TO: PRRIP GOVERNANCE COMMITTEE
FROM: PRRIP EXECUTIVE DIRECTOR'S OFFICE
SUBJECT: SCORE RECOMMENDATION FOR ELWOOD RESERVOIR
 GROUNDWATER RECHARGE
DATE: AUGUST 27, 2019

Elwood Reservoir Groundwater Recharge Project

TO: PRRIP SCORING SUBCOMMITTEE
FROM: PRRIP EXECUTIVE DIRECTOR'S OFFICE
SUBJECT: ELWOOD RESERVOIR GROUNDWATER RECHARGE SCORING ANALYSIS
DATE: AUGUST 31, 2018

**Memorandum: Analysis of Return Flows Associated with Seepage from Elwood Reservoir
Hahn Water Resources (Revised May 18, 2018)**

Figure 2. Calculated vs. constant pumping capacity

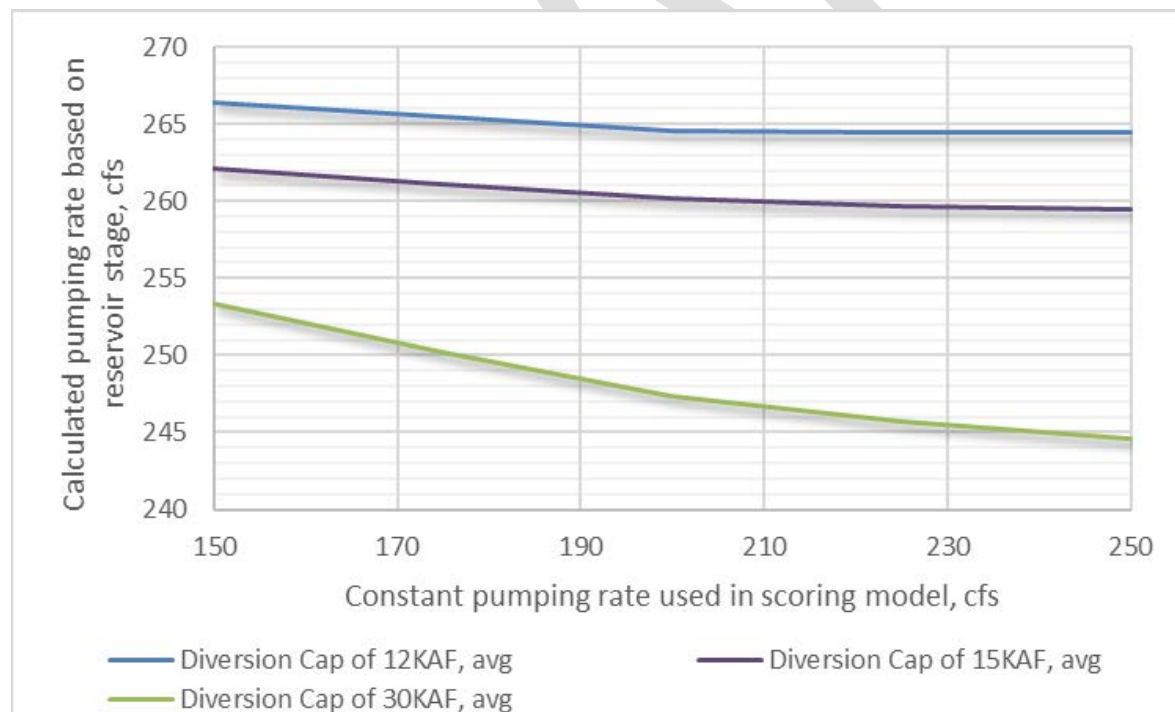
La asked about the pump station capacity that conveys water from the E-65 Canal into Elwood, noting that with a maximum pumping rate of 275 cfs, the 250 cfs used for the analysis seems to be too high. Griebeling explained the assumptions made in selecting that pumping rate. Steinke also said the rate is high, since 250 cfs is only possible at lower reservoir volumes. Shawcross asked if a pump curve could be added into the analysis spreadsheet to make the pumping rate more dynamic. Drain said the EDO should also discuss the pumping rate with Steinke.

Griebing explained the EDO's approach to evaluating pumping rate sensitivity, showing Figure 2 from the revised memo. The EDO tested a range of fixed pumping rates and calculated variable pumping rates based on Elwood end-of-month storage. In nearly all cases tested, the average of variable pumping rates exceeded the 250 cfs pumping rate originally assumed for the analysis, with the exception of a diversion cap of 30,000 AF, in which case the average pumping rate dropped slightly below 250 cfs. **Drain asserted that the analysis suggested no reason to change the assumed 250 cfs pumping rate. There were no objections from the committee.**

Figure 5. Elwood recharge diversion caps and corresponding project scores

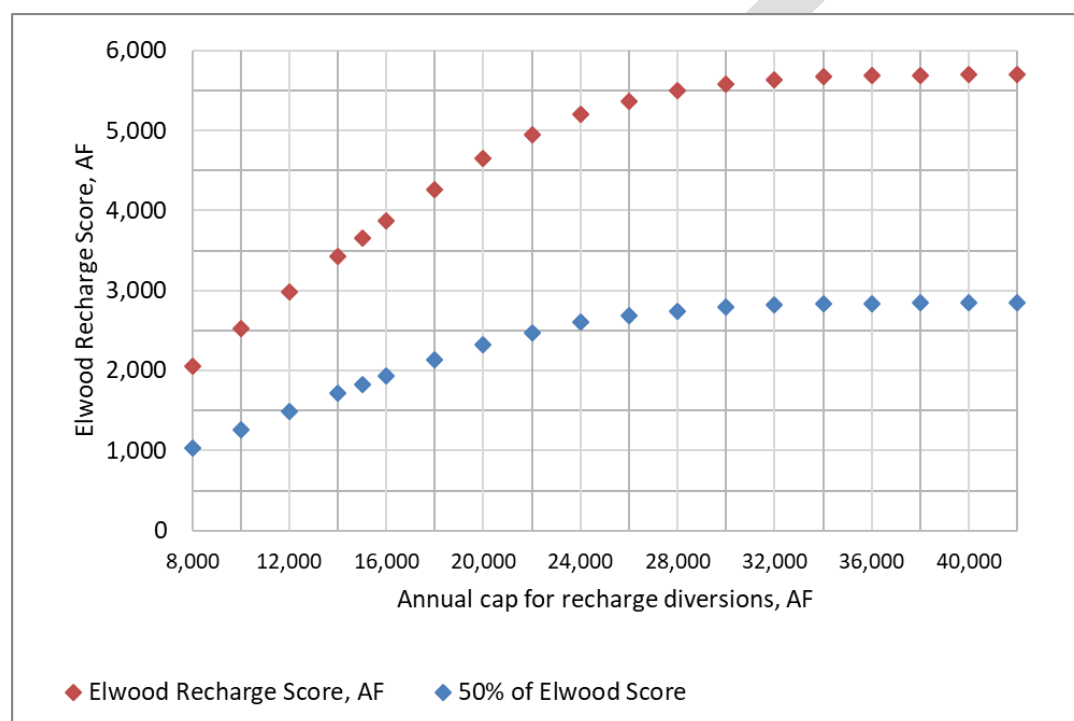
Drain noted, based on Figure 5 in the Elwood score memo, that there are differences in the score if the cap is 12,000 AF vs half of 24,000 AF. Should the score be based on the Program considered in isolation or the Program getting half of the maximum recharge capacity collectively available to the Program, the state, and Tri-Basin NRD? Griebing said we assume the overall cap is somewhere between 28,000 AF and 32,000 AF. Farnsworth read from the WSA: excess flows are diverted, divided 50/50 between Program and other parties, Program not to be billed for more than 12,000 AF without written approval from the Program.

Extensive discussion followed. Strom noted that the state has a contract for up to 13,500 AF of recharge annually. Barels suggested that the contract limit of 12,000 AF needed to be taken into consideration. Drain recommended using the curve in Figure 5 as the basis for the score, providing a mechanism for the GC to make future revisions if needed. There was discussion of whether the Program might regularly get more than 50%, but Steinke said the state and Tri-Basin are likely to fully use their half of the recharge capacity. Drain offered another suggestion of splitting the difference of the scores with a total cap of 30,000 AF and a total cap of 24,000 AF, which would mean a score of 2,700 AF for the Program. The discussion continued, and Farnsworth countered that the Program doesn't want to be paying for water that isn't scored. Farnsworth recommended going ahead with the score corresponding to half of a capacity of 30,000 AF, since that's what CNPPID thinks is a reasonable expectation of the total recharge cap. The Program and CNPPID could work to amend the current WSA accordingly.

Drain made a definitive recommendation for the GC to use the Figure 5 curve for assigning score and making future adjustments if needed. EDO will revise the figure to note that the curve as shown is for all Elwood recharge users and will add a 50% curve for the Program. Econopouly clarified that this would mean a Program score corresponding to half the score for a total recharge cap of 30,000 AF. Altenhofen and Econopouly agreed with the premise of Drain's recommendation.

With no objections, the Scoring Subcommittee recommended a score of 2,800 AF based on half of the score with a 30,000 AF cap (5,600 AF), per the score vs. capacity curve in Figure 5 of the score memo.

- Score is to be based on the score vs. capacity curve (Figure 5 in the memo), with revisions as noted in these minutes. The score for the Program will be 50% of the total score associated with a reasonably assumed maximum recharge capacity of 30,000 AF. **The Scoring Subcommittee recommends a score of 2,800 AF for the Elwood Reservoir groundwater recharge project.**

Figure 1. Cumulative baseline (no added Elwood recharge) baseflow from the documented COHYST model (k=80) and EDO model (k=55). Negative values represent a losing stream, positive values represent a gaining stream.

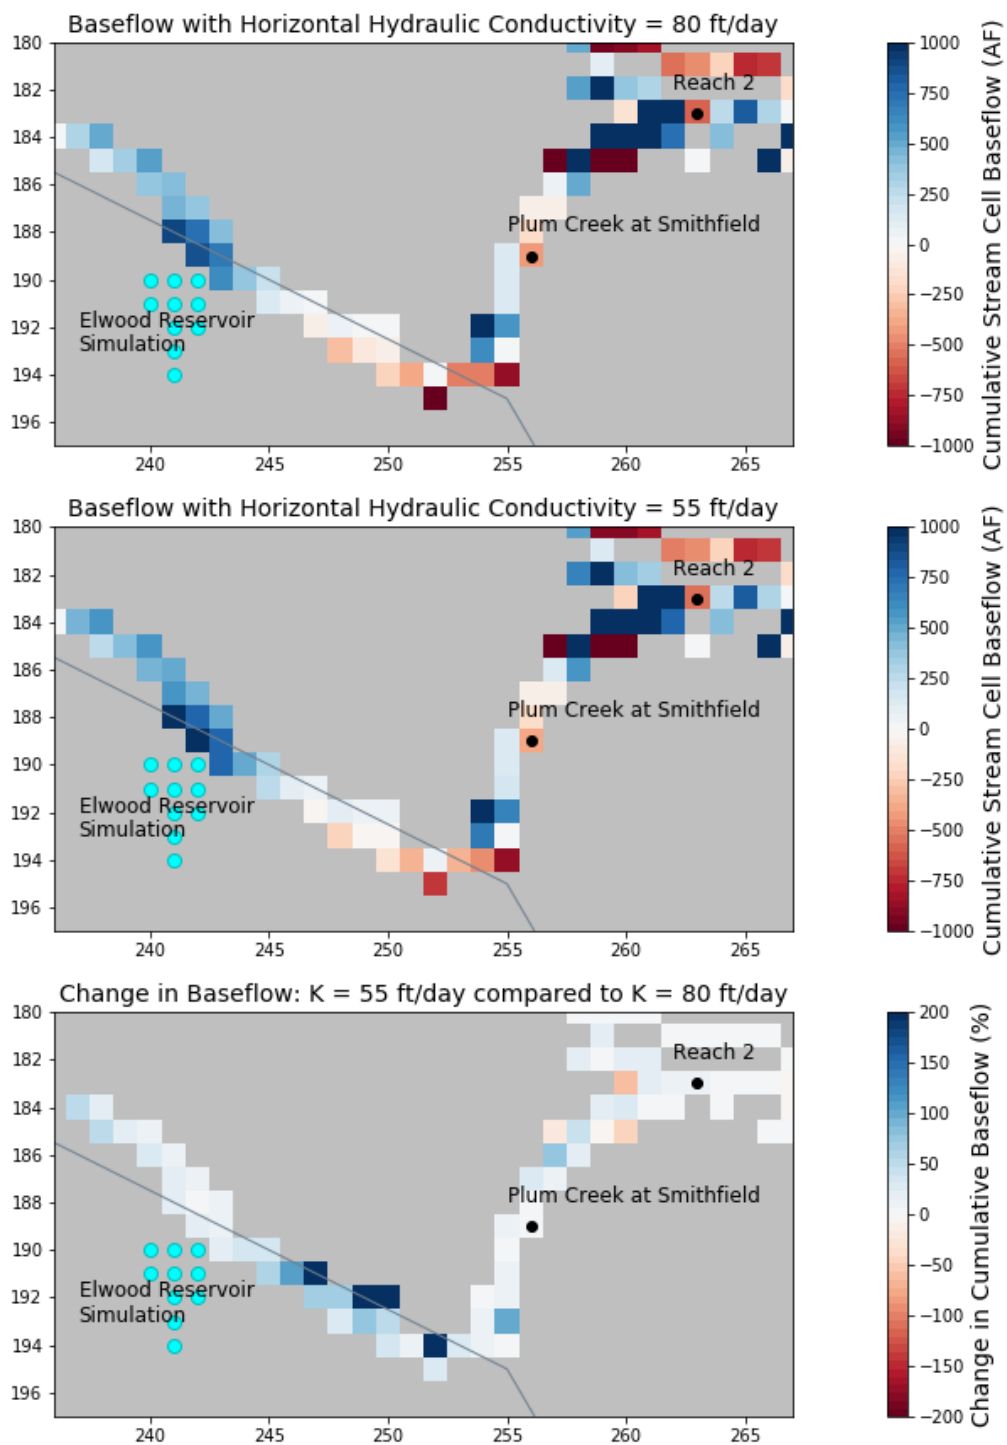
We did not find a significant change in the direction of the Plum Creek stream to aquifer interaction resulting from the conductivity modification (Figure 1).

Figure 2. Time series of accretions to streamflow at a downstream location from adding 10 cfs of recharge from Elwood using the documented COHYST model or EDO Elwood model.

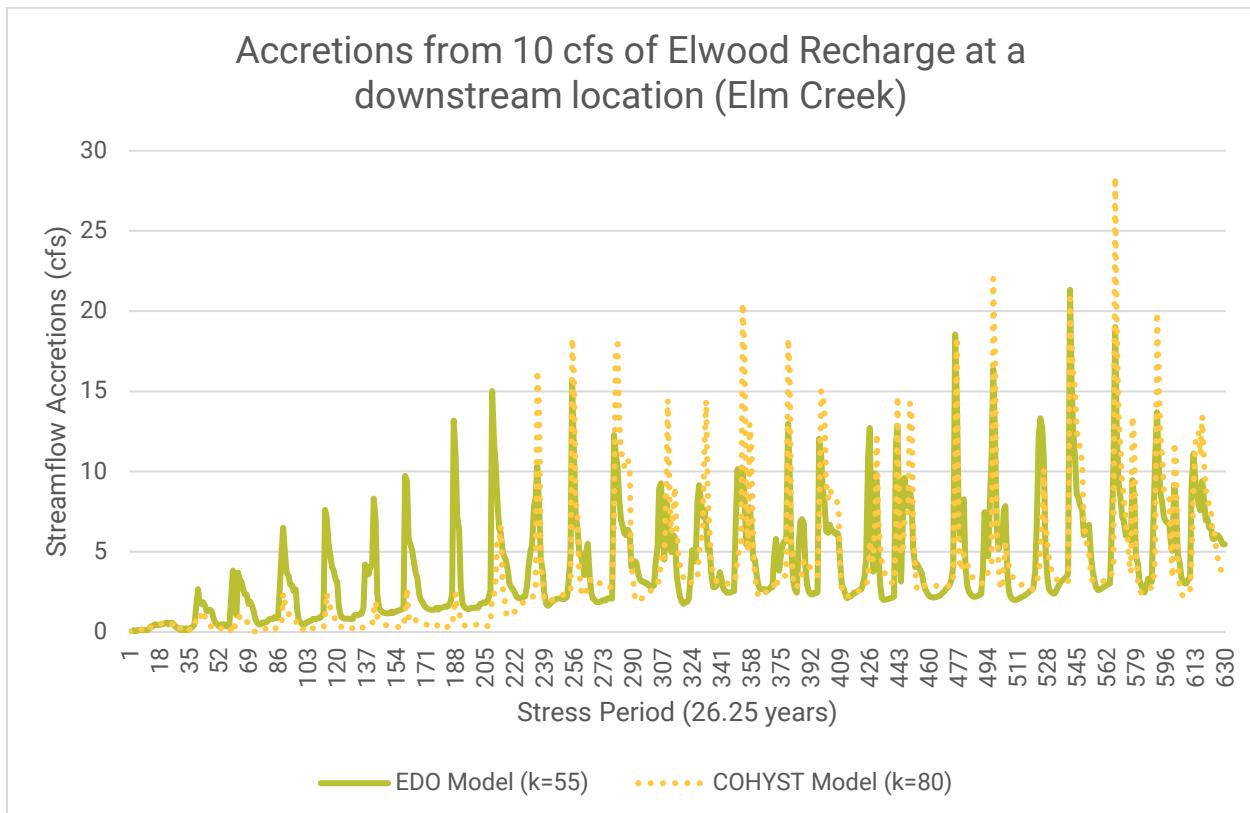
The timing of the accretions is affected by the conductivity change (Figure 2). The accretions with the COHYST model do not occur until later in the simulation, but then occur at a greater magnitude through the rest of the simulation. As shown in an example pulse-flow scenario, this is likely due to the groundwater mound along Plum Creek and the Platte River taking longer to build since the conductivity is greater in the opposite direction of the stream than EDO's model (Figure 3).

Figure 3. Plum Creek Stream Package – Gains due to Elwood Recharge

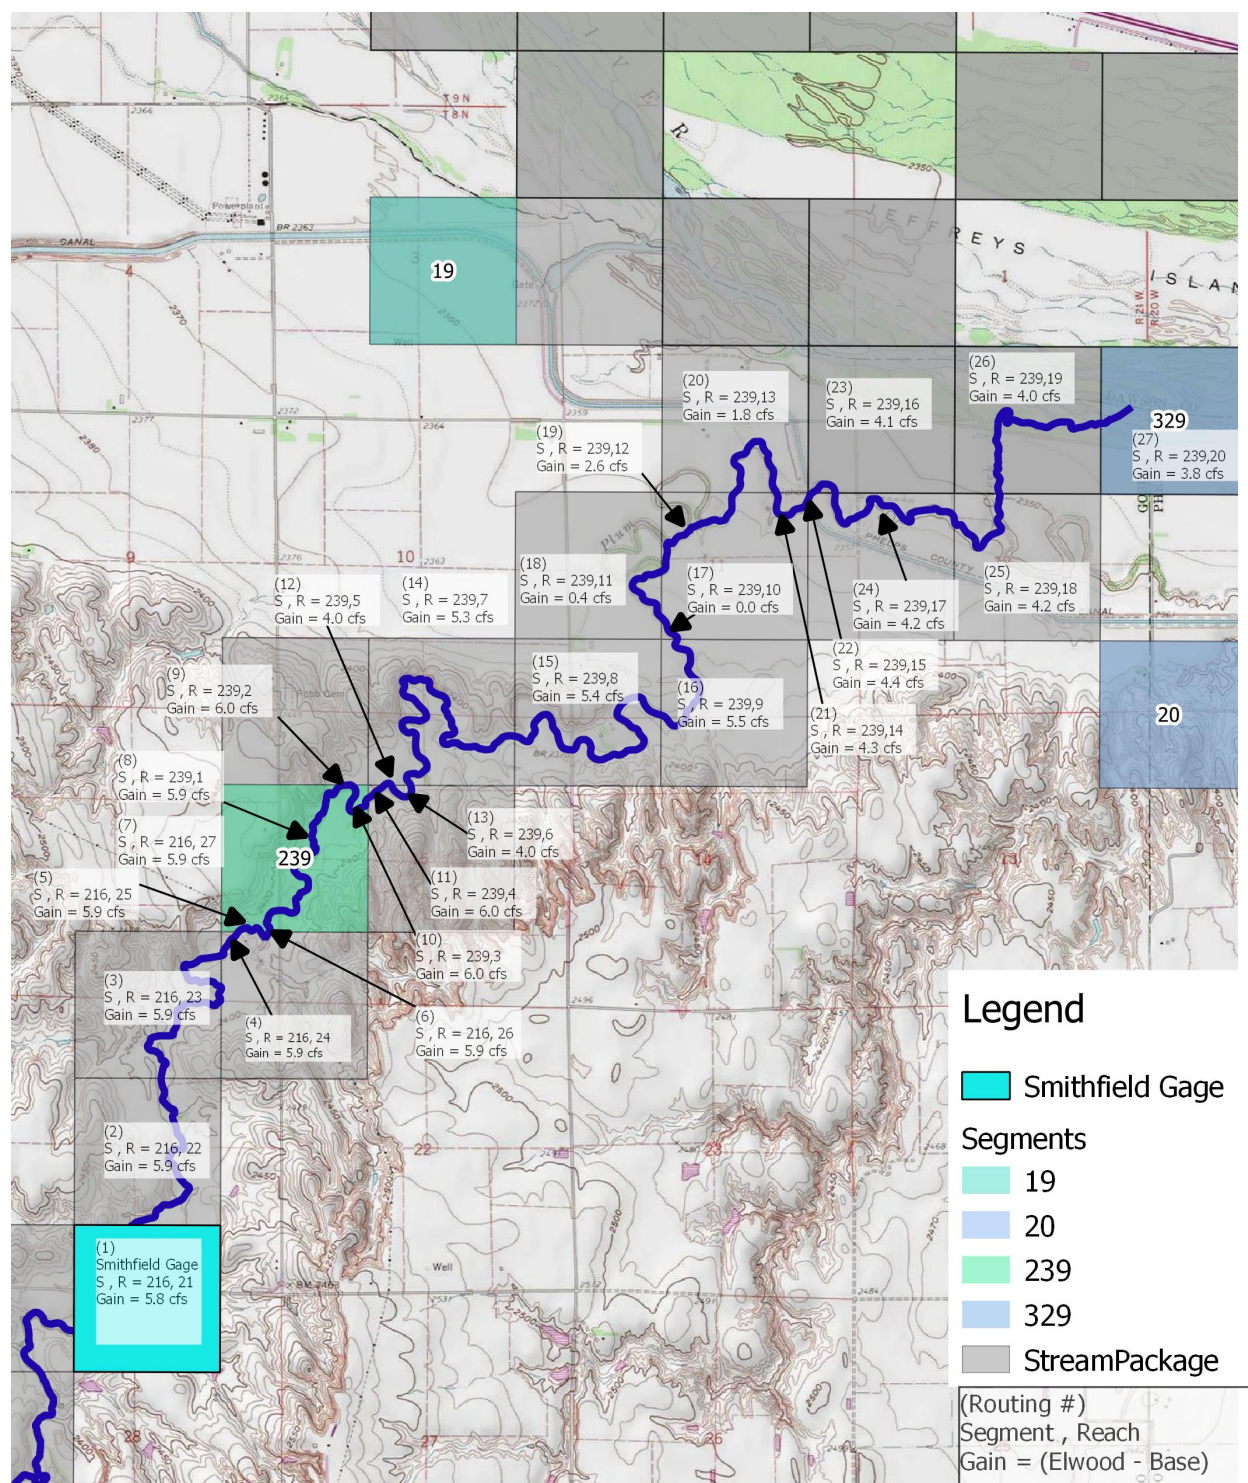
The COHYST model appears to improperly route water through the lower portion of Plum Creek from the Smithfield gage to the south channel of the Platte River. The model shows this segment of Plum Creek behaving in an erratic fashion, as seen in **Table 2** and **Figure 3** which tabulates the changes in streamflow for each reach of this segment. The gains are calculated as the flow into the cell from the Elwood Recharge run minus the flow into the cell in the base model run, thus providing the change to streamflow as a result of the Elwood Recharge. Between reaches 4 and 5, the change in streamflow drops from 6.0 cfs to 4.0 cfs. Between reaches 9 and 10, the change in streamflow drops from 5.5 cfs to 0 cfs. Overall, the reach shows the change in streamflow to decrease from 5.9 cfs in reach 1 to 3.8 cfs in reach 20. This behavior does not make sense on an intuitive level and there is not a reality-based explanation for why this portion of Plum Creek would behave in this fashion. Apart from the recorded measurements at the Smithfield gage, discharge measurements at other locations are extremely limited. Nonetheless these measurements show on average a gain in Plum Creek in the segment between the Smithfield gage and the junction with the Platte River of about 13 percent. The EDO staff and Bill Hahn have observed this segment of Plum Creek in person and have never observed it to suddenly lose large amounts of flow. Additionally, the staff of the Tri-Basin Natural Resources District (TBNRD) cannot recall Plum Creek ever going dry below the Smithfield gage³. The model should at a minimum route the 5.9 cfs of increased streamflow seen in reach 1 of the segment down to the Platte River without any losses. If the model were to adequately capture the observed behavior of Plum Creek, it would likely show additional increases in streamflow as water is routed down the segment, with the amount of increased streamflow reaching the south channel of the Platte River greater than 5.9 cfs.

In addition to the inconsistent streambed conductance, the model routes the lower segment of Plum Creek through multiple model cells, as seen in **Table 2** and **Figure 3**. For example, the model cell in row 187 column 258 contains reaches 1 and 3 and the cell in row 185 column 261 contains reaches 10, 12, and 14. This happens when flow in Plum Creek enters a cell, then leaves the cell only to return back to the cell at a downstream location. The stream package also overlaps reaches when one segment ends and second begins. This irregular routing scheme is a relic of the automated process used to build the streamflow routing (SFR) package in MODFLOW. We are unsure how this routing scheme might affect the accuracy of the model's calculation of stream gains and losses.
